Waste Licence:	W0129-02 Hollywood Great
Re.:	Waste Licence Review Application
Condition(s):	Not Applicable
Enclosed Docs:	(i) Drawing Ref. WLR9, Rev C Layout 1 (ii) Summary List of Monitoring Locations

**Summary List of Monitoring Locations  
Murphy Environmental, Hollywood (W0129-01)**

Title  
**PROPOSED MONITORING LOCATIONS**

Project No. 07507190061	Engineer AS	Drawing No.
File No. WLR	Reviewed by TVM	<b>WLR9</b>
Created by AS

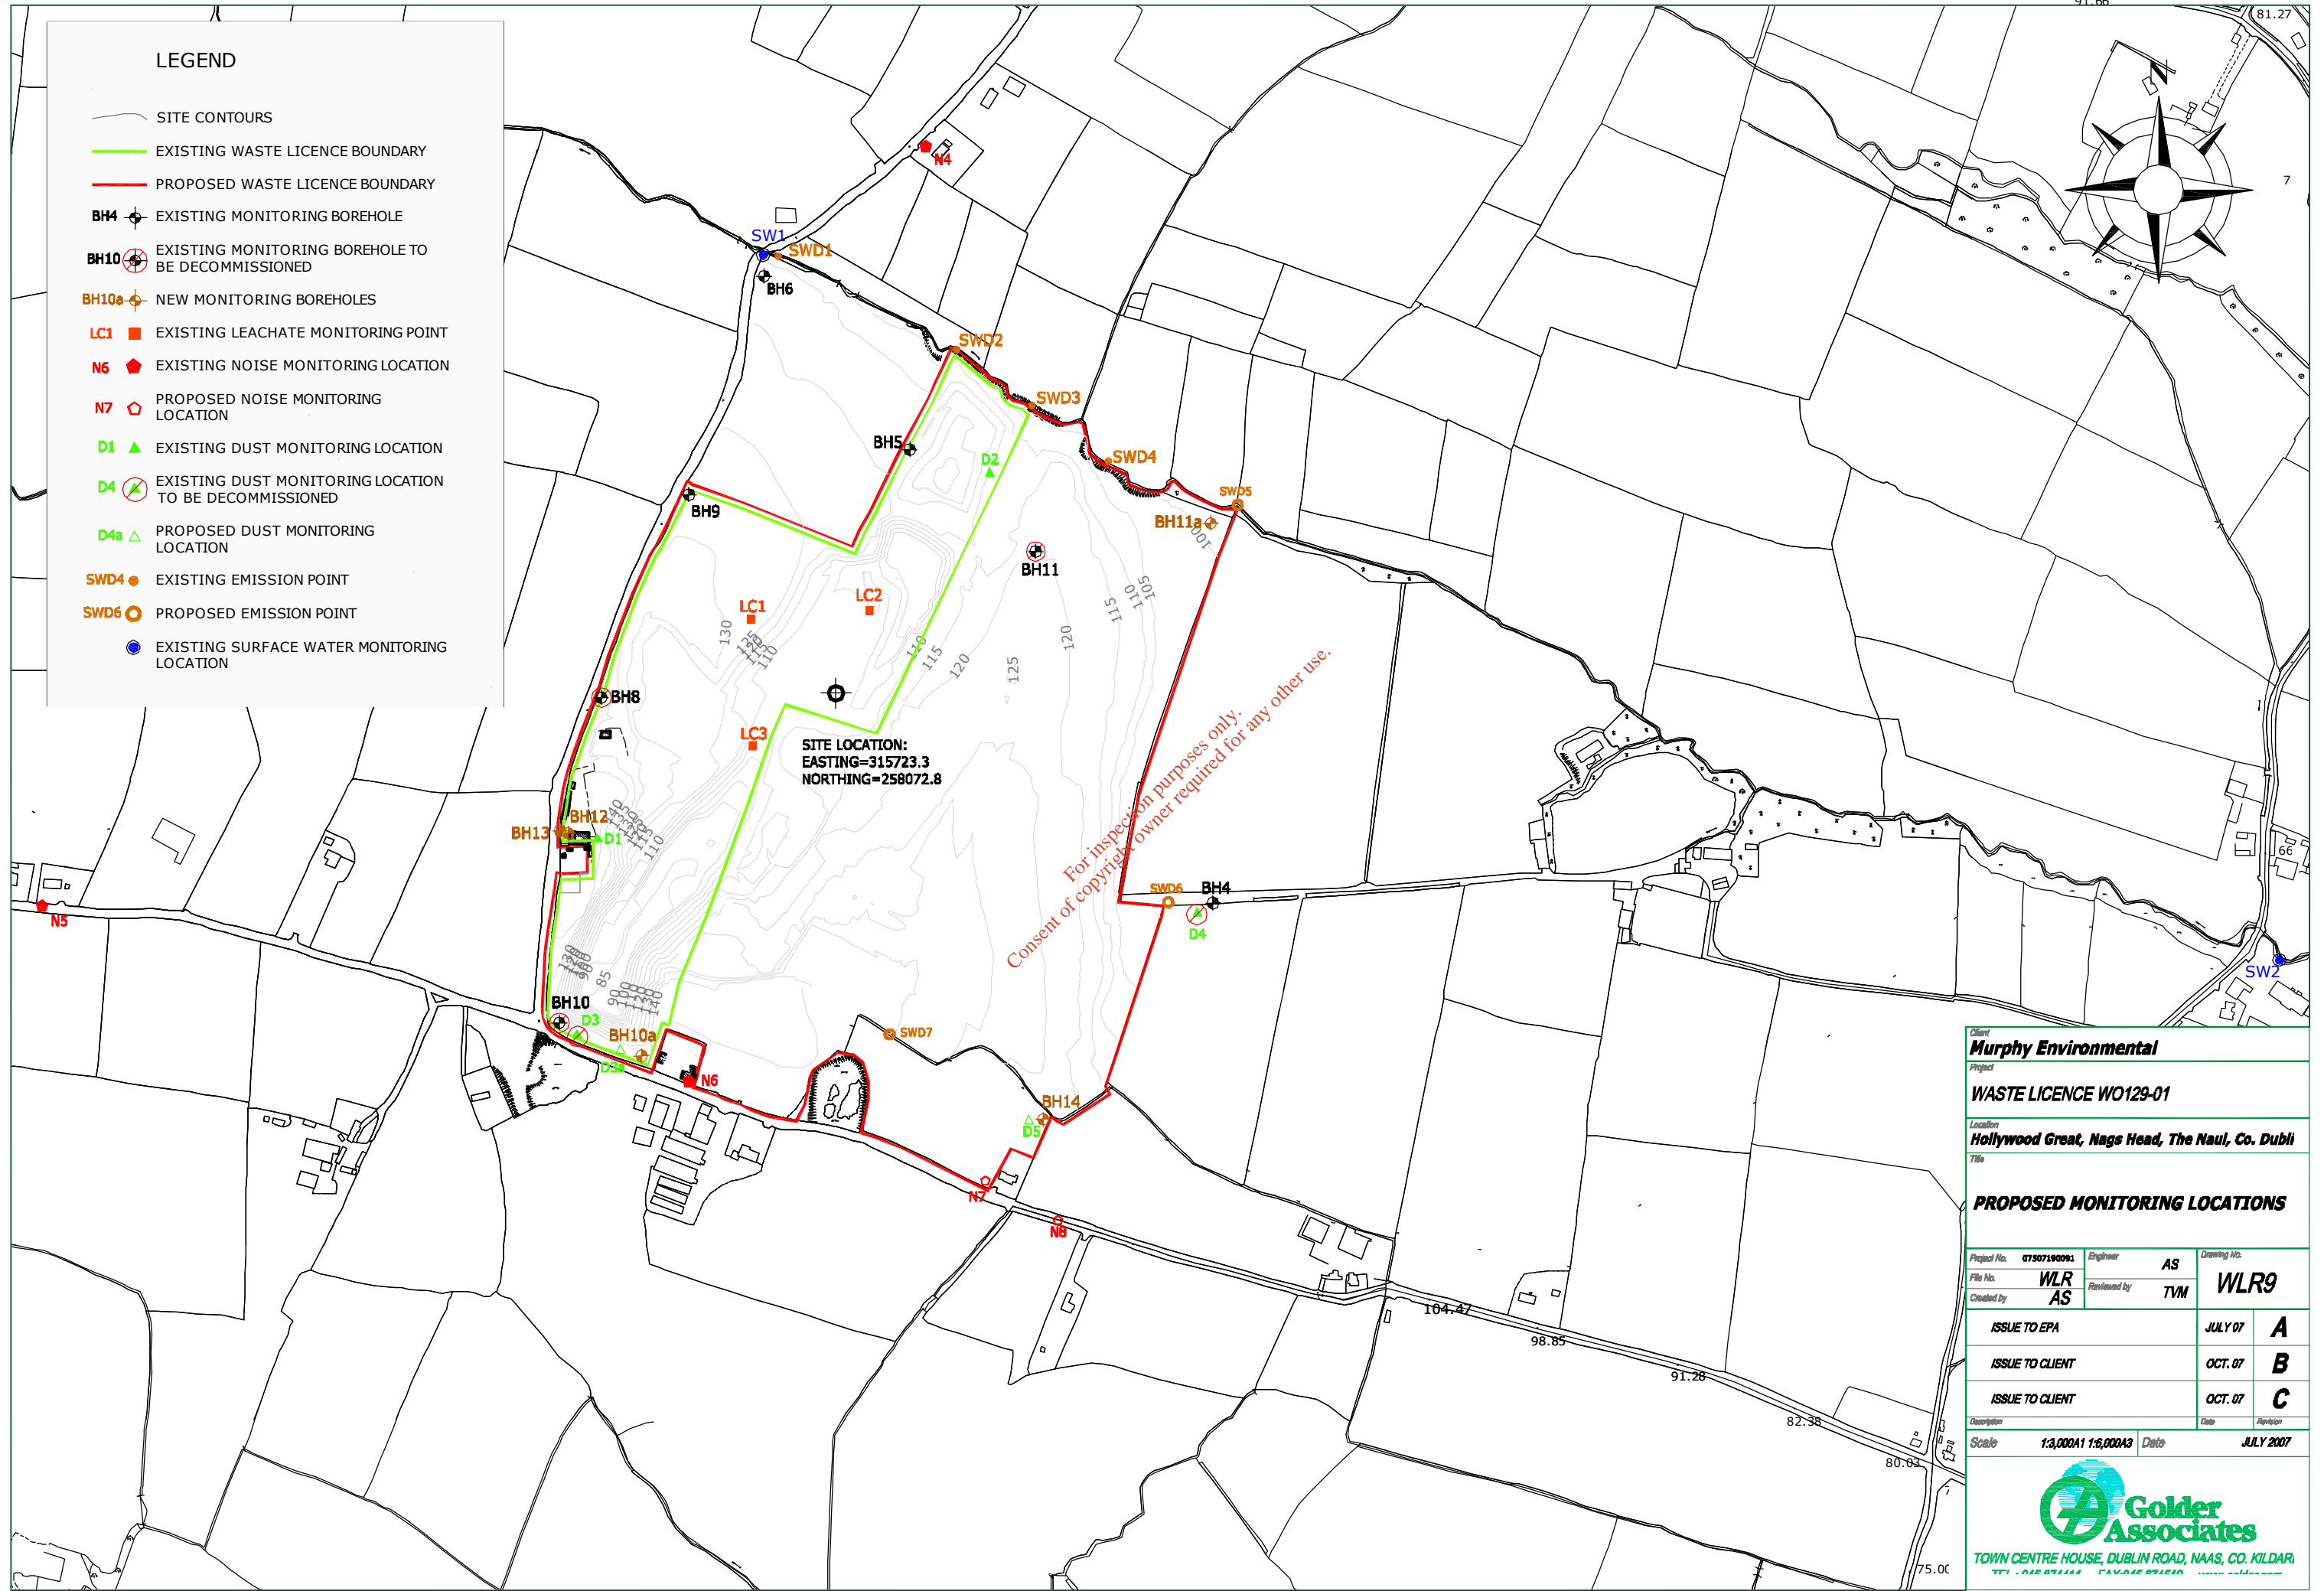
Please find attached the proposed up-to-date monitoring location drawing with all surface water discharge points and surface water monitoring point SW2 as per existing licence.

This drawing supersedes that sent with letter ref: W0129-02/LOD/070907.

<b>Monitoring as per Waste Licence W0129-01</b>	<b>Monitoring for the purpose of the Waste Licence Review Application</b>	<b>Proposed Ongoing Monitoring Locations, following Review of W0129-01</b>	<b>Comments</b>
<b>Dust</b>			
D1	D1	D1	No change
D2	D2	D2	No change
D3	D3	D3A	EPA has verbally agreed we can move this point to beside BH10A for ease of access
D4	D4	-	D4 has been tampered with in the past; D5 will replace it

-	D5	D5	To address a new sensitive receptor. It is proposed this will replace D4
-	D6	-	To address a new sensitive receptor, however ongoing monitoring not proposed – potential impact can be assessed by D5
<b>Noise</b>			
N4	N4	N4	No change
N5	N5	N5	No change
N6	N6	N6	No change

-	N7	N7	To address a new sensitive receptor
-	N8	N8	To address a new sensitive receptor
-	N9	-	To address a new sensitive receptor, however ongoing monitoring not proposed – potential impact can be assessed by N8
<b>Surface Water Discharge</b>			
SWD1 <i>(discharge after flowing through silt trap/oil interceptor)</i>	SWD1	SWD1	No change
SWD2 <i>(Water pumped from base of quarry)</i>	SWD2	SWD2	No change Discharge currently inactive, but may be required again in future
SWD3 <i>(Water discharge from new settlement pond)</i>	SWD3	SWD3	No change
SWD4 <i>(Quarry water discharge from rock cell at south of site)</i>	SWD4	SWD4	No change

<b>Monitoring as per Waste Licence W0129-01</b>	<b>Monitoring for the purpose of the Waste Licence Review Application</b>	<b>Proposed Ongoing Monitoring Locations, following Review of W0129-01</b>	<b>Comments</b>
SWD5 (Quarry water pumped from rock cell at south of site (discharge currently inactive at this point, but may be required in future))	-	SWD5	New proposed surface water discharge point
SWD6 (Quarry water pumped from rock cell at south of site: point of discharge at the proposed licence boundary)	-	SWD6	New proposed surface water discharge point
SWD7 (Quarry water pumped from rock cell at south of site: point of discharge from underground pipe to open drainage ditch)	-	SWD7	New proposed surface water discharge point.

-	Flow into Settlement Pond 1		To monitor effectiveness of settlement ponds – ongoing effectiveness will be monitoring at SWD3
-	Flow into Settlement Pond 2	-	To monitor effectiveness of settlement ponds – ongoing effectiveness will be monitoring at SWD3
<b>Leachate</b>			
LC1	LC1	LC1	No change

-	LC2	LC2	New leachate monitoring BH
-	LC3	LC3	New leachate monitoring BH
<b>Surface Water</b>			
SW1	SW1	SW1	No change
SW2	SW2	SW2	No change
<b>Groundwater</b>			
BH4	BH4	BH4	No change
BH5	BH5	BH5	No change
BH6	BH6	BH6	No change
BH8	BH8	-	Propose to decommission as appears to be damaged/blocked/unsuitable – BH12 and BH13 will replace
BH9	BH9	BH9	No change
BH10	BH10 BH10A	BH10A	Propose to decommission BH10 as appears to be damaged/ blocked/ unsuitable and replace with new borehole, BH10A

<b>Monitoring as per Waste Licence W0129-01</b>	<b>Monitoring for the purpose of the Waste Licence Review Application</b>	<b>Proposed Ongoing Monitoring Locations, following Review of W0129-01</b>	<b>Comments</b>
BH11	BH11	BH11A	Propose to decommission as excavation on all sides and replace with new borehole, BH11A
-	-	BH12	Installed as part of new drilling programme
-	-	BH13	Installed as part of new drilling programme
-	BH14	BH14	Installed as part of new drilling programme
